## Washington Public Power Supply System

G02-81-0427  
October 27, 1981

Subject: SUPPLY SYSTEM NUCLEAR PROJECT NO. 2  
AUXILIARY SYSTEMS BRANCH QUESTIONS

Reference: Letter, R. L. Tedesco to R. L. Ferguson,  
"Request for Additional Information  
for the review of the WNP-2 Facility",  
dated April 27, 1981

Replaces FSAR  
Figure 4.6-5b

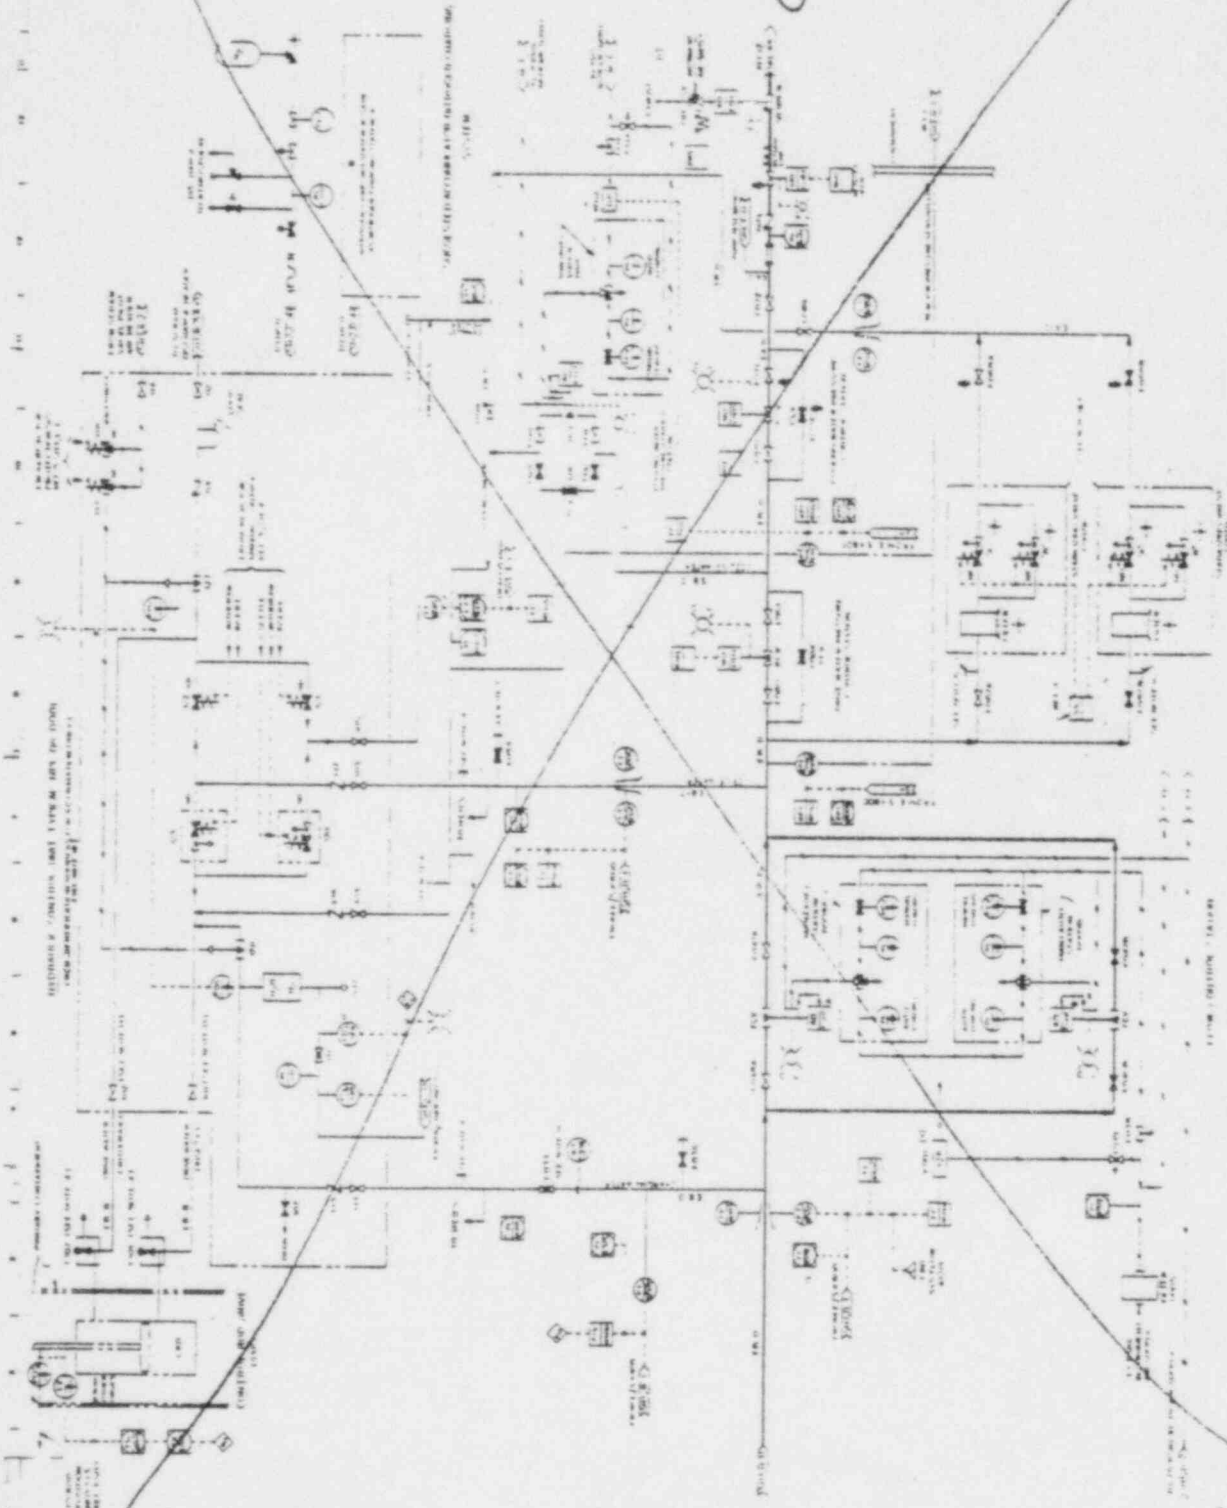
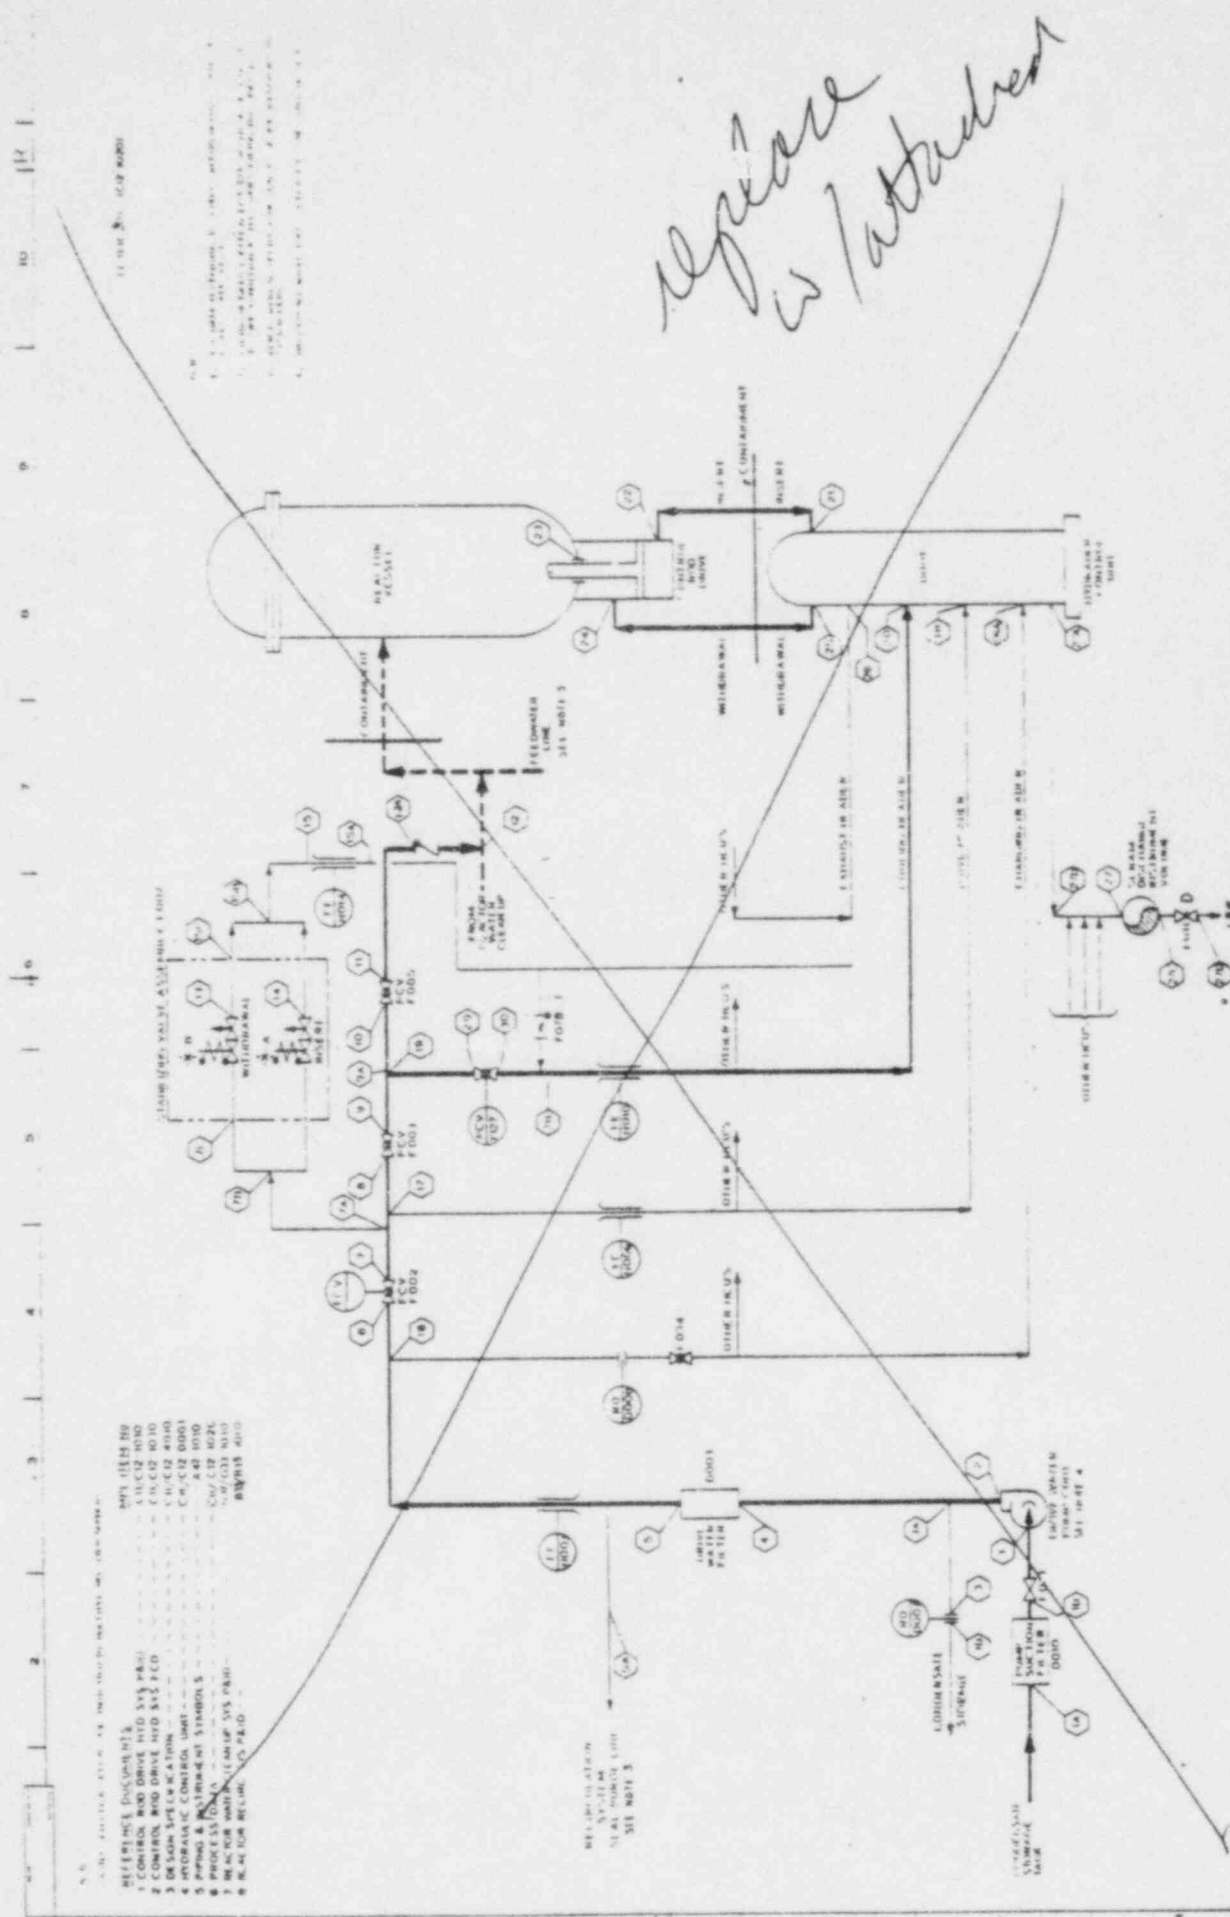
Table 1.3-8 indicates specific design changes from the PSAR to the FSAR for the CRD system. The design changes for the CRD return line modification addressed in Question 211.019, have not been included in the text description of the FSAR and Figures 4.6-5a, 4.6-5b, and 4.6-6a have not been revised. Revise the text description in the FSAR to reflect the specific design changes in Table 1.3-8 for the CRD system and modify the above figures accordingly.

Revised FSAR Figure 4.6-5b (Amendment 16) does not appear to show valves F129, F130, F131, and F132. The applicant should explain if this is what is meant in the response by "removing the discrepancy identified above". In addition, the revised FSAR page was not provided as stated in the response. The applicant should provide the revised FSAR page and describe the revision.

Figures 4.6-5a, 4.6-5b, 4.6-6a, 4.6-6b, and 4.6-6c are revised to reflect the CRD return line modification. Figures 4.6-6d and 4.6-6e are deleted. Also, text sections 4.6.1.1.2.4, 4.6.1.1.2.4.1, 4.6.1.1.2.4.2.3, 4.6.1.1.2.4.2.4 and 4.6.2.3.2.2.8 are revised accordingly. Text section 4.6.1.1.2.4.2.5 is deleted.\*

FSAR Figure 4.6-5b (Amendment 16) does not show valves F129, F130, F131, and F132 because these valves were removed from the CRD system when the CRD return line to the RPV was eliminated.

What is meant by "removing the discrepancy identified above" in the response to Question 211.134 (later changed to 010.047) is that by submitting revised FSAR Figure 4.6-5b the discrepancy identified in Question 010.047 between the FSAR text, M528 (FSAR 3.2-4) and FSAR Figure 4.6-5b was resolved.

010.049  
TABLE 211.006-1

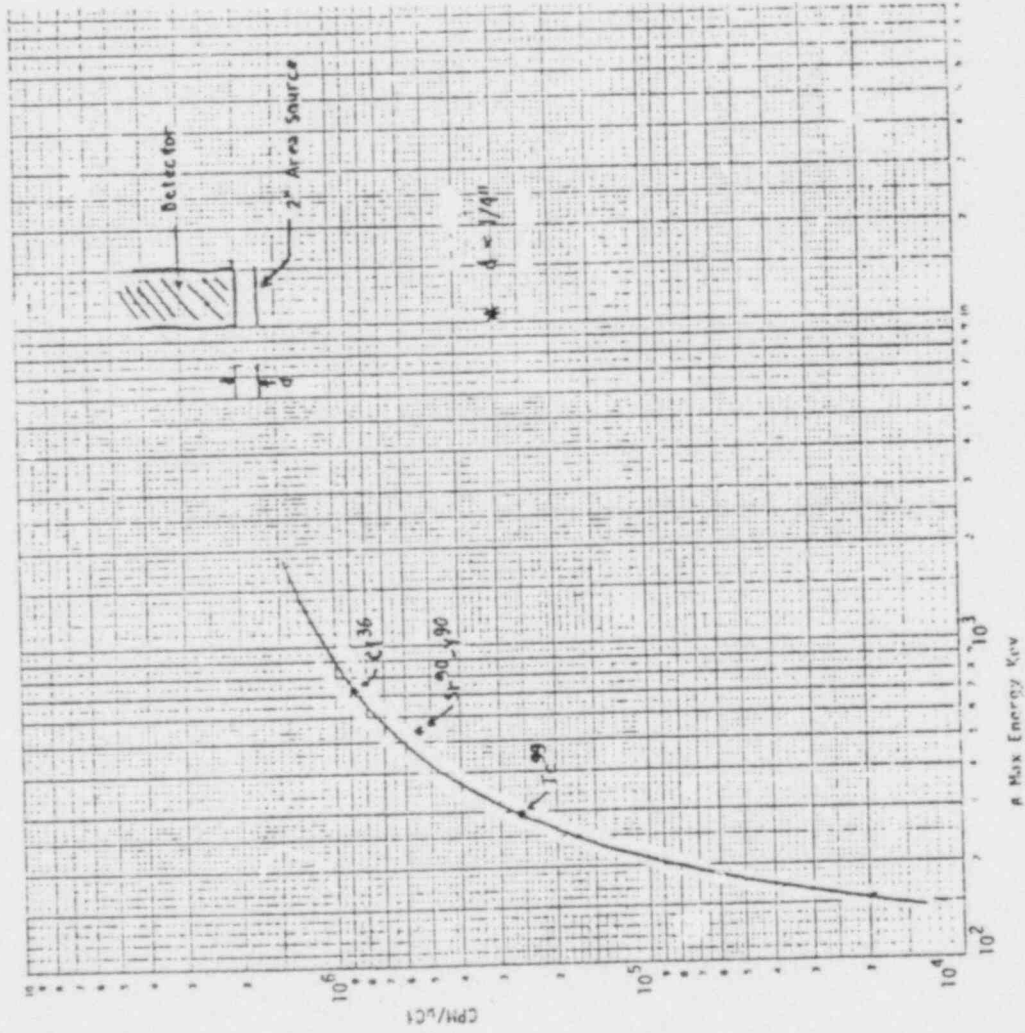
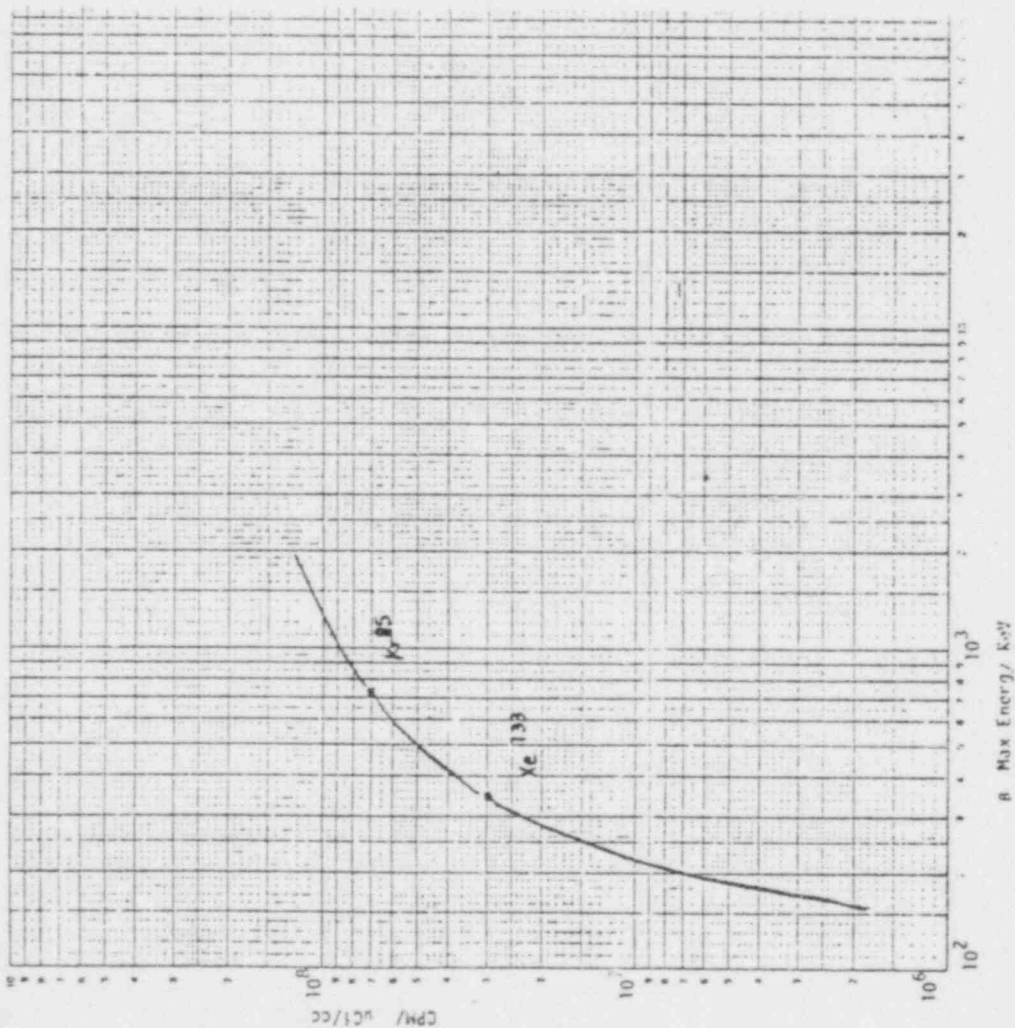
Provide a detailed discussion of the sensitivity and response times of the containment airborne radiation monitoring systems for a number of containment background activity levels. The background activity levels which should be considered are those levels in the containment that would result from leakage through the RCPB assuming: (1) relatively clean water in the reactor coolant system at the initial operation of the WNP-2 facility at power; and (2) the maximum level of activity in the reactor coolant permitted by the WNP-2 Technical Specifications. In responding to this item, assume both the normal and the maximum leakage rates identified in your response to Question 211.115. Indicate your assumptions in estimating the response times of the containment airborne radiation monitoring systems (e.g., the preset alarm level for higher background leakage and the plateout factor).

010.049 The two types of radiation monitors used in the WPPSS Nuclear Project No. 2, for monitoring the drywell atmosphere, are the particulate monitor and the noble gas monitor. The sensitivity of these two types of monitors is given in Figure ~~211.006-1~~ and ~~211.006-2~~. The same detector is used in both monitors. The detector's noise level is about 25 cpm. The minimum detectable concentration is based on doubling the background count rate. The count ratemeter range and the minimum sensitivity of both types of monitors are:

The noble gas monitor, however, even though its sensitivity is consistent with Regulatory Guide 1.45 requirements, would not be capable of detecting the additional 1 gpm leakage within one hour utilizing the criterion of double background count as positive indication. The noble gas monitor does, however, provide the most reliable and fastest means of ascertaining increased activity within containment with unidentified leakages higher than 1 gpm.
